Tool & Product Update

Models 352 and 353 Deflector Screw Interference

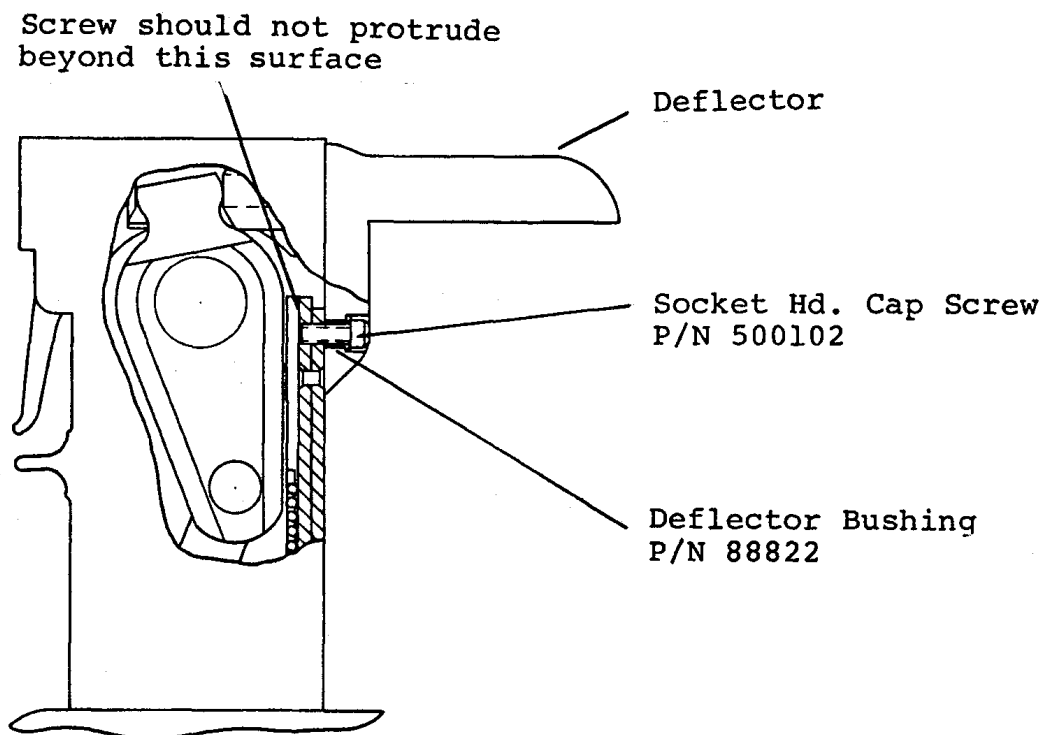
Interference of deflector screw and upper ladder bearing cage in Models 352 and 353 Installation Tools has been reported.

The machined Bushing, P/N 88822, was replaced with a 3LC Lockbolt collar which is too short for Socket Head Cap Screw, P/N 500102. This allows end of screw to protrude into path of ascending ladder bearing and shearing screw end.

Corrective action (choose one of three):

- (1) Replace 3LC lockbolt collar bushing with machined type bushing. 3LC collar is plated, machined bushing has black oxide finish.
- (2) Shorten/grind .050 off screw end, P/N 500102.
- (3) Place .050 washer between screw head and bushing.

Note: Bushing, P/N 88822, correct length is .313 plus or minus .010
